U.S. NUCLEAR REGULATORY COMMISSION  
OFFICE OF INSPECTION AND ENFORCEMENT

Report No. 50-146/79-01

Facility Name: Saxton Reactor (in decommission status)

Inspection Summary:

FIGURE 2

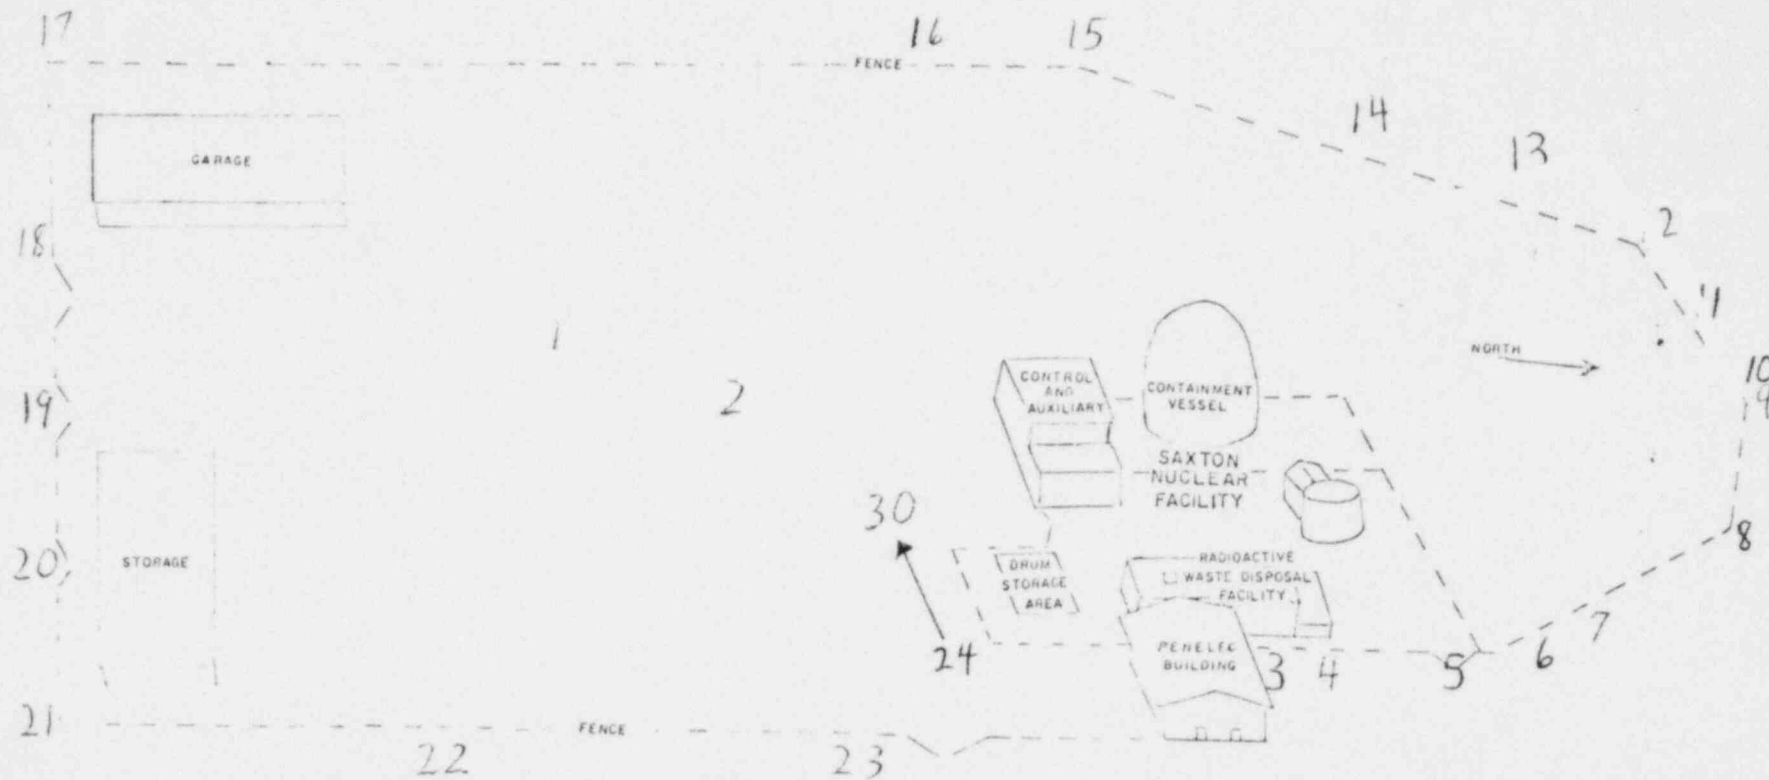
Figure 2 is a rough sketch showing the relative positions of the fence surrounding the Saxton Nuclear facility, (also referred to as the SNEC controlled area), and the longer fence surrounding the Saxton Steam Generating Station, (also referred to as the PENELEC fence). The PENELEC fence is, in turn, located approximately in the center of a 150 acre PENELEC tract of land with a minimum distance of a thousand feet between the fence and any boundary with the PENELEC tract.

Sample locations are shown in Figure 2. The results of the analysis of these samples are presented in Table III.

With the exception of points #10 on Figure 1 (which corresponds to a point near #6 on Figure 2) and #5 on Figure 2, no indication of radioactivity was noted as a result of the Ludlum survey. At points #10 and #5 an increase above background levels was noted. These points were then measured with an Eberline E 120 with an HP 190 probe because this instrument, although less sensitive than the Ludlum, is accurately calibrated to read in mr/hr (dose rate). At both points a dose rate of about 0.25 mr/hr was observed on contact with the undisturbed surface of the soil.

Point 5, Figure 2, was outside of, but within a foot of, the closed vehicle gate indicated in Figures 1 and 2 at the northeast corner of the SNEC boundary fence. There is no PENELEC fence that encloses this section of the SNEC fence. Before the Saxton reactor was decommissioned this gate was used by a gas service truck, and possibly other vehicles. During the dismantling of the Saxton facility this entrance might have been used by equipment involved.

The licensee has cleaned up all of the identified radioactive contamination that was outside the fenced areas. The licensee's report on surveys and cleanup has not yet been received.
